# **Proposed Marlborough Environment Plan**

**Section 42A Hearings Report for Hearing Commencing  
February 2019**

**Report on submissions and further submissions  
topic: Water Allocation and Use**

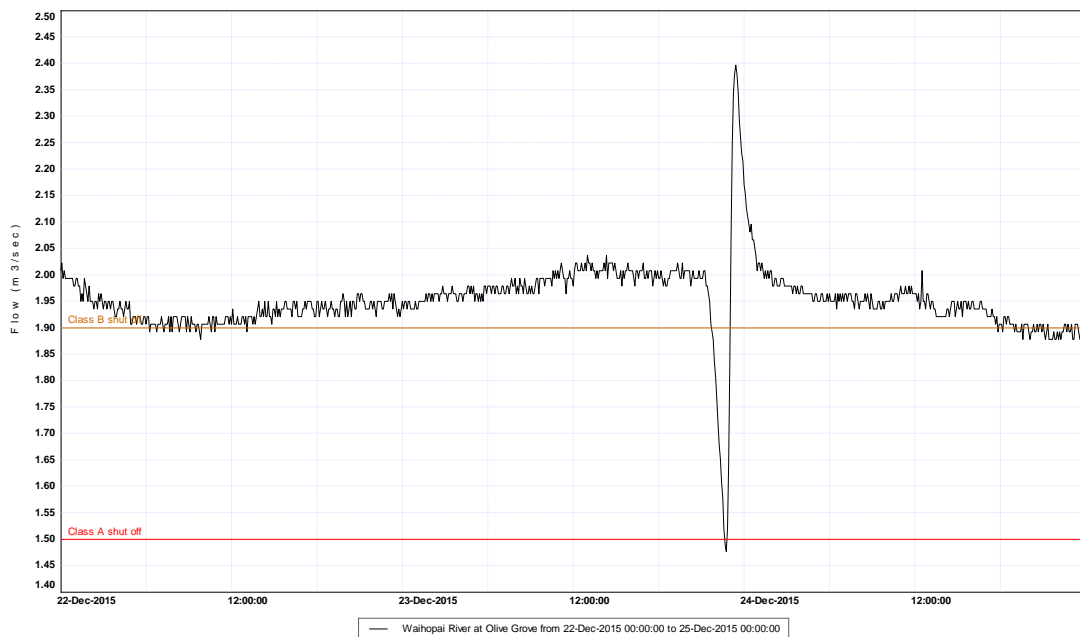
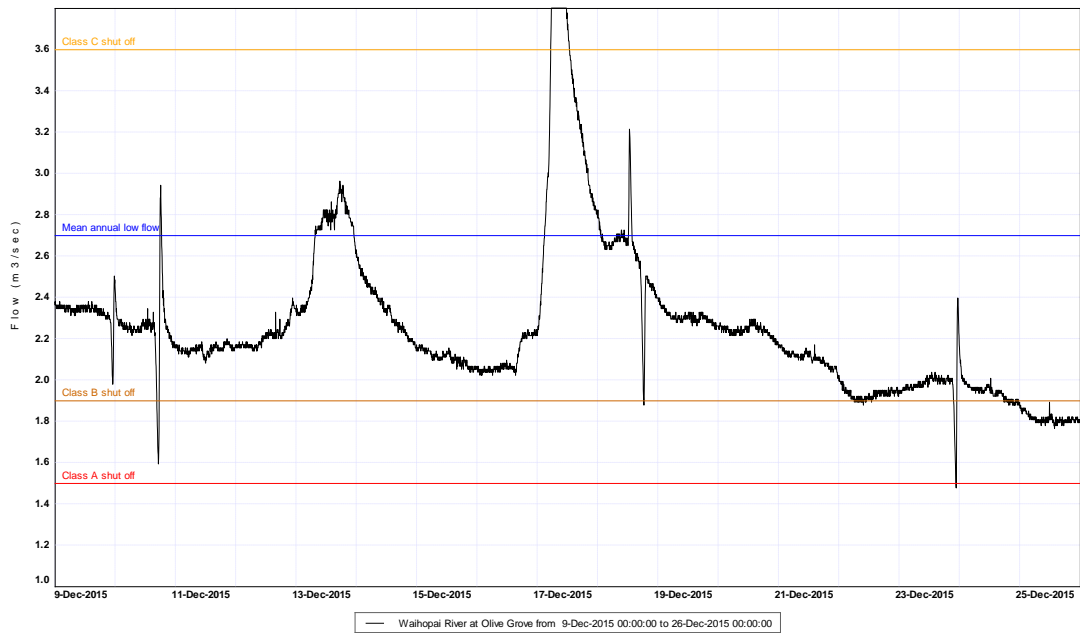
- There are a number of reasons why daily average flow was recommended by the WAWG, and subsequently adopted by Council.
  - Recorded flows in rivers do not drop in a steady linear fashion, due mainly due to slight water level fluctuations caused by wind, or turbulence. A fluctuation in water levels of just 1-2 mm can result in the recorded flows fluctuating either side of a specified cut-off level sometimes at very short intervals.
  - Rivers sometimes also often exhibit slight diurnal fluctuations due to daily catchment evapotranspiration variations. These diurnal fluctuations can result in a trigger level being marginally breached and reset on a daily basis.
  - An example of water level variation affecting recorded flows at Rai Falls is shown on the graph below.

- The Waihopai River quite regularly experiences significant spikes in flow as a result of the Waihopai Power scheme tripping off due to faults. The spikes can be upward, downward, or both, and usually have a magnitude of more than 0.5m<sup>3</sup>/s, but a duration of less than 2 hours. The spikes are such that they can cause the Waihopai River status to go from class A and B both being available, to neither being available within half an hour, then resetting just an hour or so later. Examples of this is shown on the graphs below, the second, enlarged graph also shows significant instances of recorded flow fluctuating either side of the threshold due to minor changes in level.

Background – Branch Hydro Electric Power scheme (HEPS)

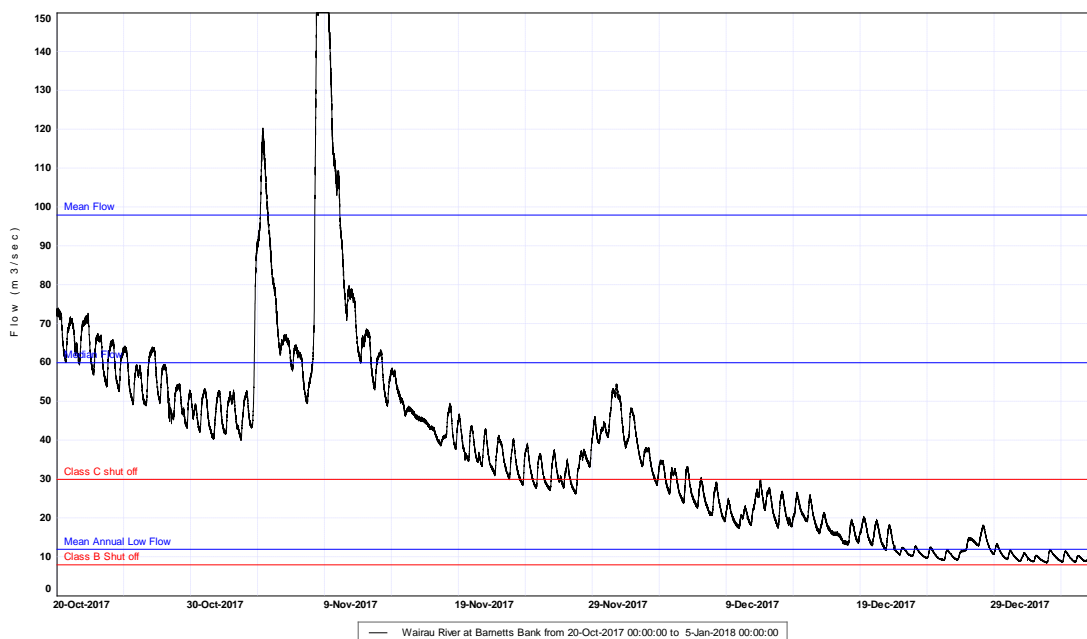
- The Branch HEPS was constructed in 1983 by the Marlborough Electric Power Board (MEPB) as a local generation initiative and subsequently purchased by Trustpower Limited about 1998. Water is diverted from the Branch River, about 4km

upstream of the Wairau River confluence and taken via canal to the Argyle holding pond. From here it passes through the Argyle power station, then on to the Wairau power station, before being discharged to the Wairau River approximately 7km downstream of the Wairau-Branch confluence.

The effects of hydropeaking on managing Wairau River FMU water restrictions

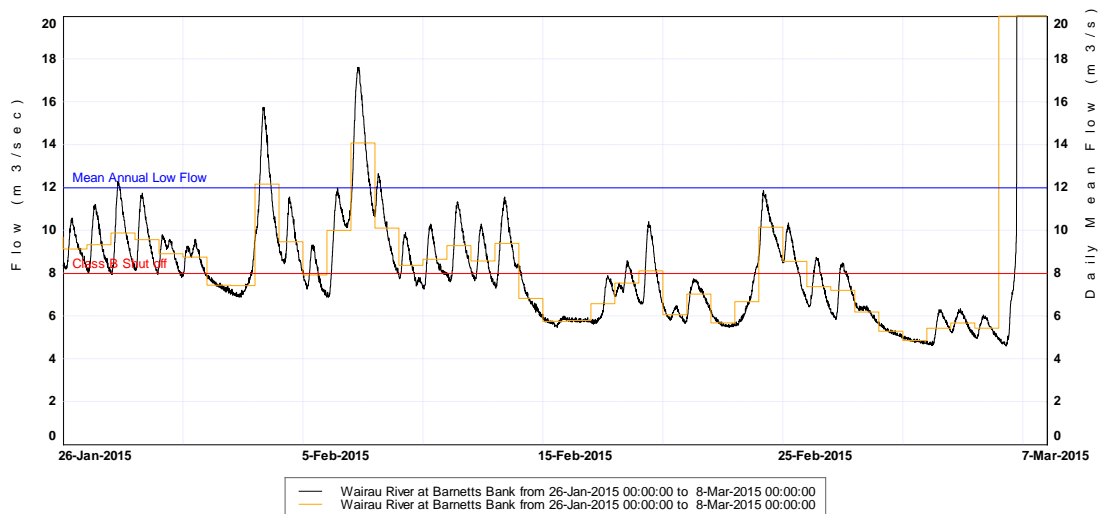
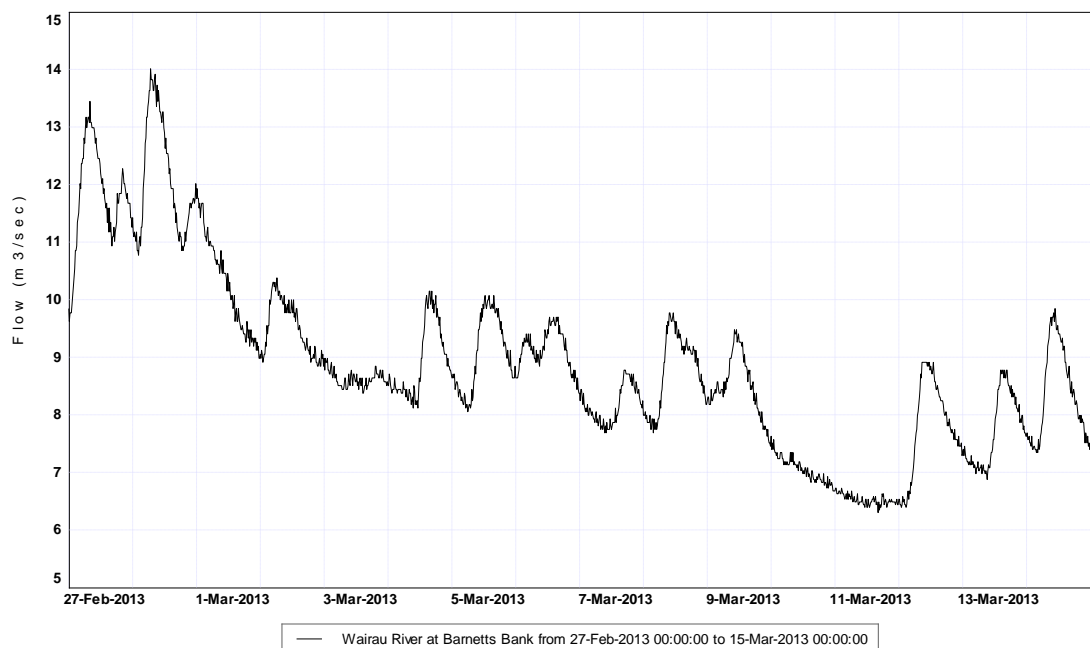
- As can be seen from the previous graph the hydropeaking effects cause the recorded river flow to fluctuate significantly either side of a given threshold (class C in this case) on a daily basis for a number of days before finally being consistently below the threshold.
- If managed on an instantaneous basis, some of these shutoffs would be only hours long, giving little time for users to react to and shut down their systems. To complicate matters further, the users who are affected by these shutoffs are all between 6 and 18 hours flow time upstream of the monitoring site, meaning the shutoff would probably not stop the flow falling below the shutoff threshold, rather it

The graph above shows both instantaneous and daily average flows, and the timing and duration of shutoffs which would result from each method.

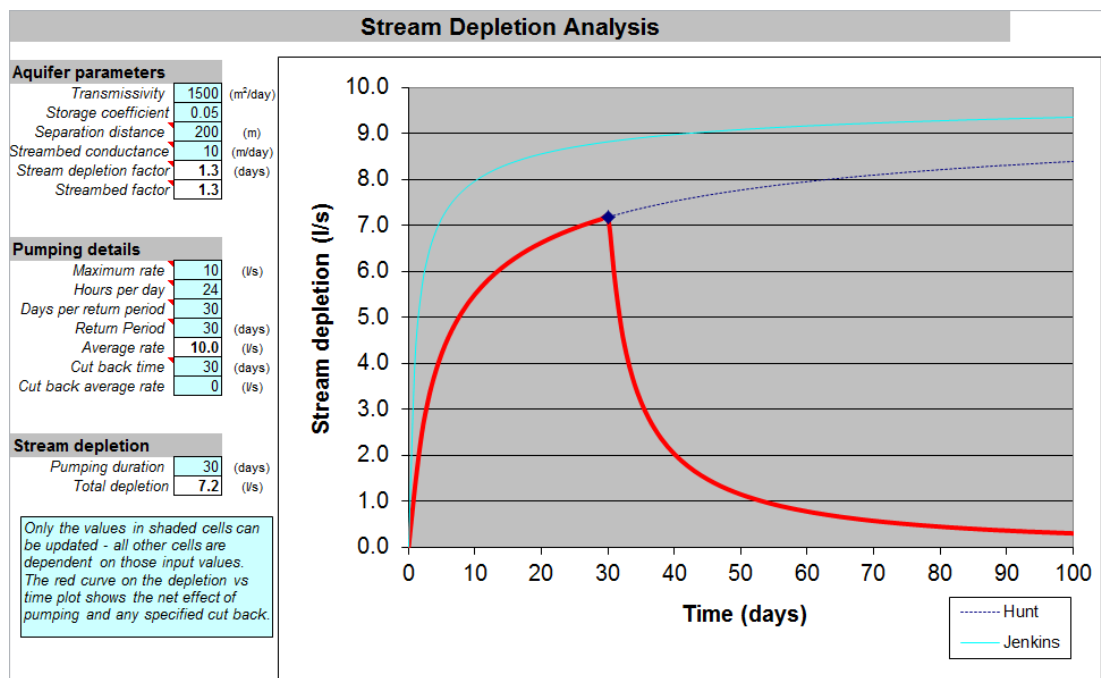
- One further peculiarity of operating a power generation scheme which targets peak power generation prices on the market is that there is lower electricity demand, and therefore lower prices, during weekends. Consequently, during low flow periods Trustpower Limited often choose not to generate during the weekend, but instead retain all allowable Branch inflows in the Argyle pond. This stored water is then used for generation during the week allowing slightly higher generation rates when spot power prices are higher. The graph below shows the results of weekend hold backs on the following days;
  - 3 March 2013 (Sunday)
  - 10-11 March 2013 (Sunday-Monday)

- As the graph shows the result of holding back 3-5m<sup>3</sup>/s of Branch flow is to cause a significant drop in flows in the Wairau River the following day, typically Sunday and/or Monday. This can artificially force flows below the cut-off threshold as is the

case here on 10-11 March. The effects of a prolonged holdback on instream biota is arguably worse than the shorter term effects of the daily, or twice daily hydropeaking fluctuations which submitters are concerned with. However no submissions were received on the effects of holding back water, either through the MEP process, or during the 1999 replacement of the Trustpower Limited consent.

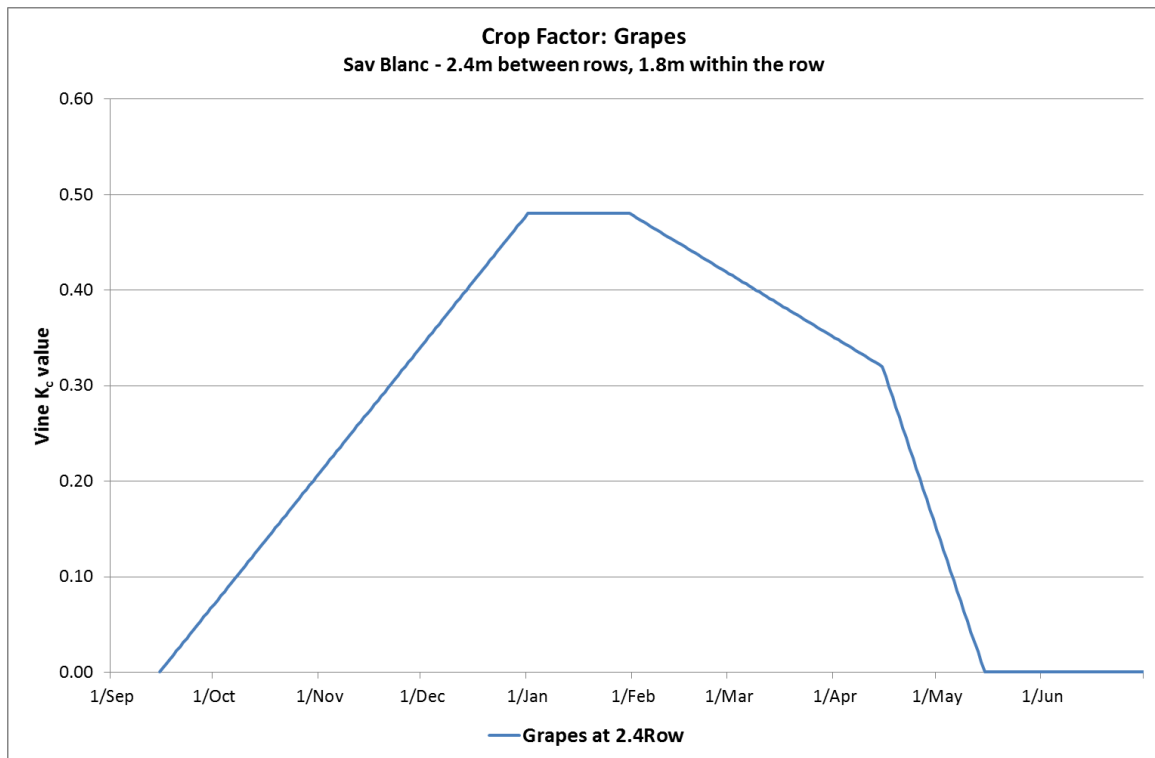
464. It is recommended that Policy 5.2.11, and its associated explanation, is retained as notified.

465. Schedule 3 of Appendix 6 is titled “*Minimum Flows and Levels for Water Takes*”. The following submission are those made on Schedule 3 of Appendix 6 as they relate to aquifers, and are therefore associated with Policy 5.2.11.
